Drawing status **FOR COMMENT**

County Flats, Sandfields
OAD_5174
1250

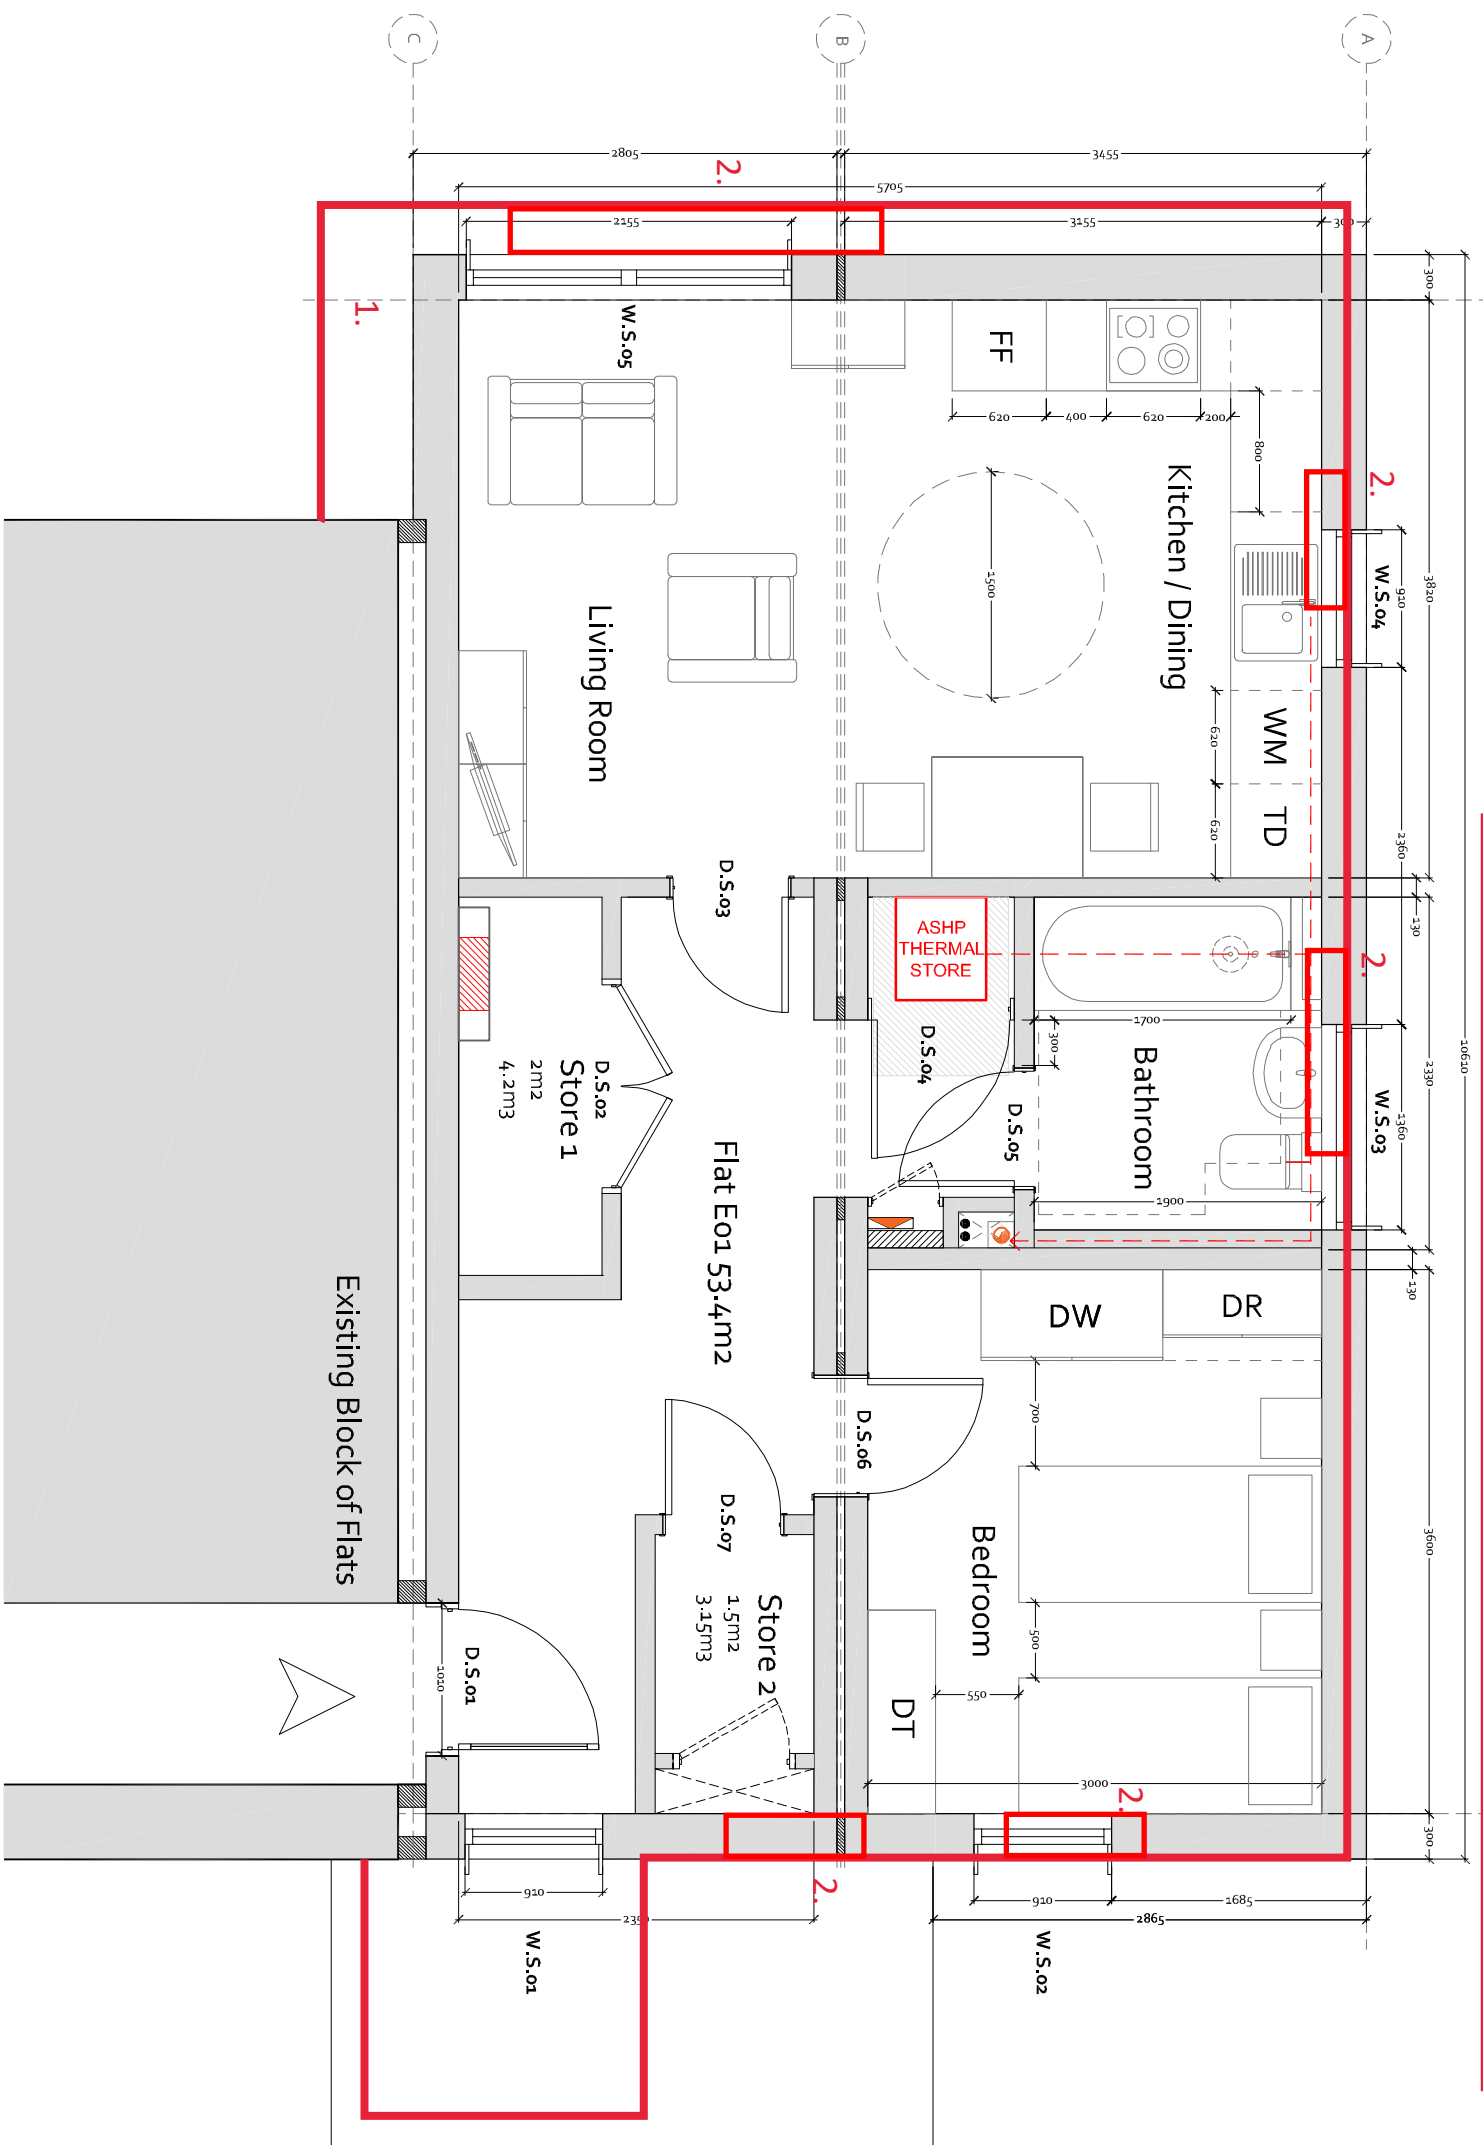
1. Modular end links re-positioned slightly off existing buildings, with the party wall straightened and porch projections aligned with this wall, to ensure modular construction can be achieved off site.
2. Windows have been slightly re-positioned to the new build to suit the structural design of the modular units and the constraints of the timber frame.
3. Parapet to modular end blocks have been lowered by approx 900mm to comply with the structural wind loadings and timber frame design.
4. Corner windows have been removed and replaced with 2no. Windows on either corner, again due to the structural and timber frame design of the blocks.
5. PV panels have been omitted from the end modular units to suit the structural and timber frame design of the blocks.
